Figure 3.5.1
 Preliminary Water Circuit
 Merriam Junction Sands
 DEIS

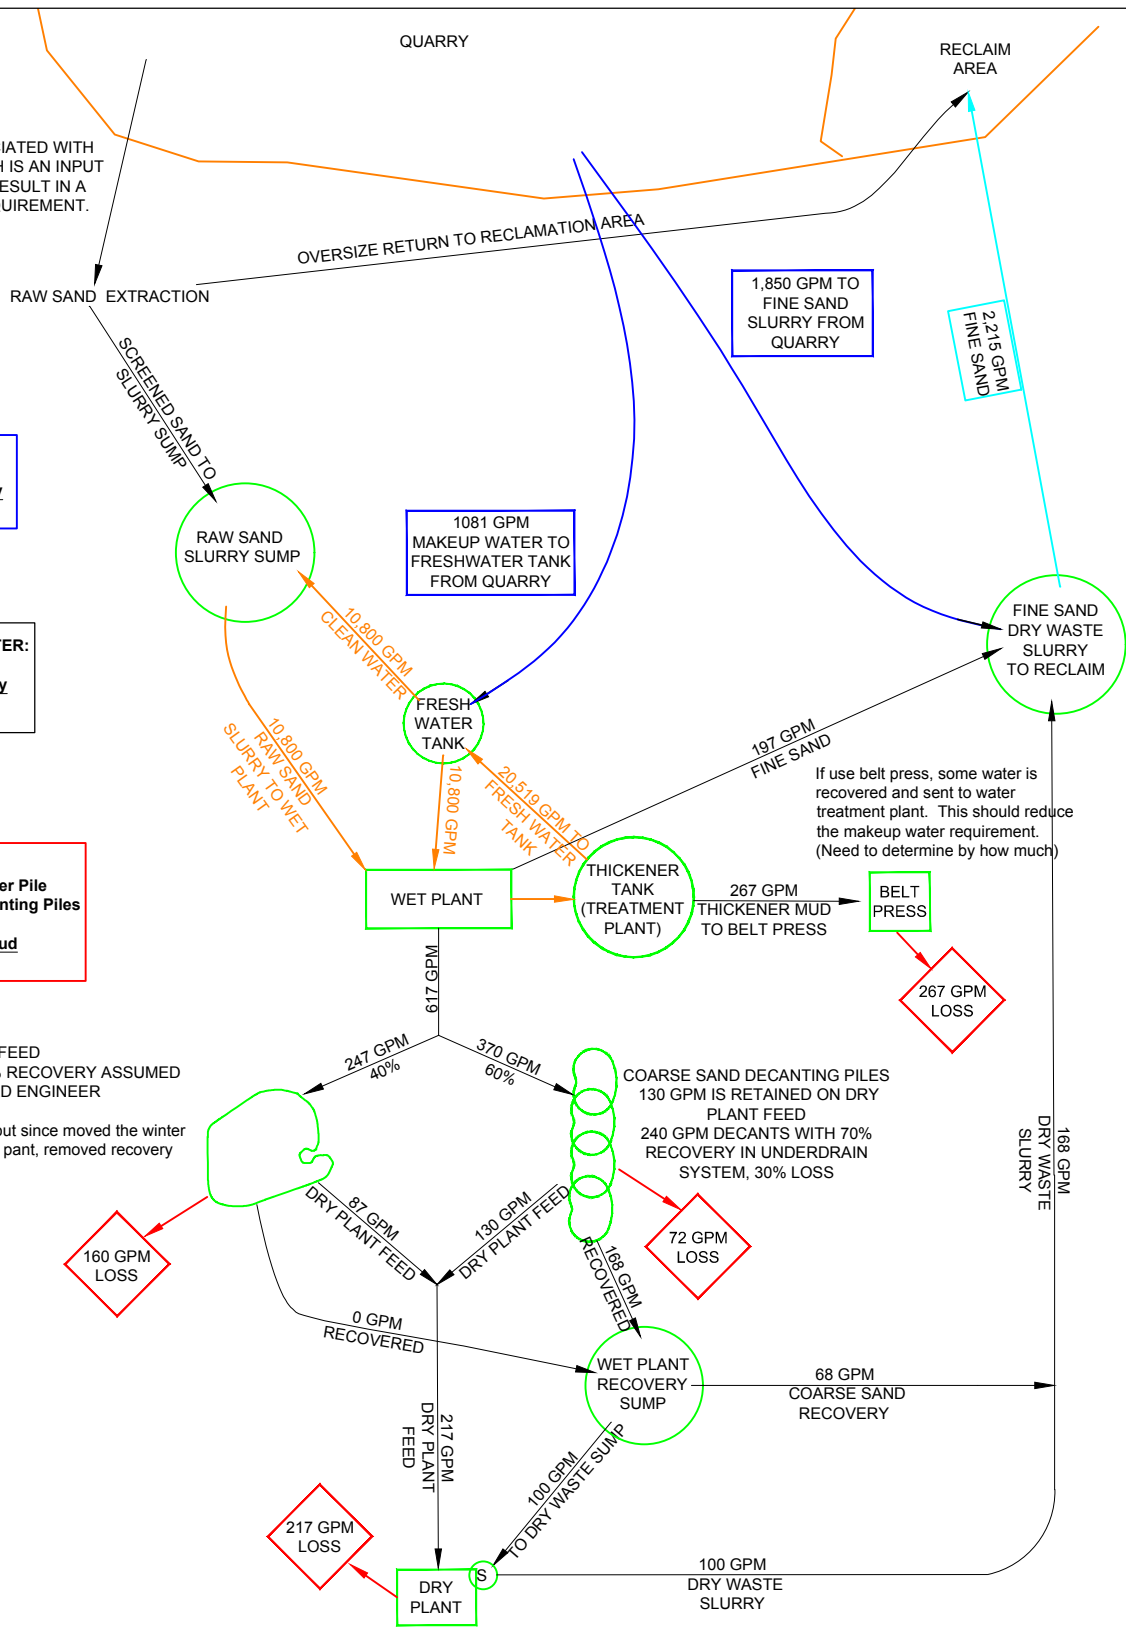
DOES NOT ACCOUNT FOR WATER ASSOCIATED WITH RAW SAND EXTRACTED FROM MINE WHICH IS AN INPUT TO THE SYSTEM. THIS INPUT SHOULD RESULT IN A DECREASE IN THE MAKE-UP WATER REQUIREMENT.

COARSE SAND WINTER FEED
 87 GPM IS RETAINED ON DRY PLANT FEED
 160 GPM DRAINS FROM PILE WITH 0% RECOVERY ASSUMED FOR WORSE CASE CONDITION. COULD ENGINEER RECOVERY SYSTEM IF NEEDED.
 50% recovery was part of the initial plan but since moved the winter feed stockpile to lower elevation than wet pant, removed recovery system from current plan.
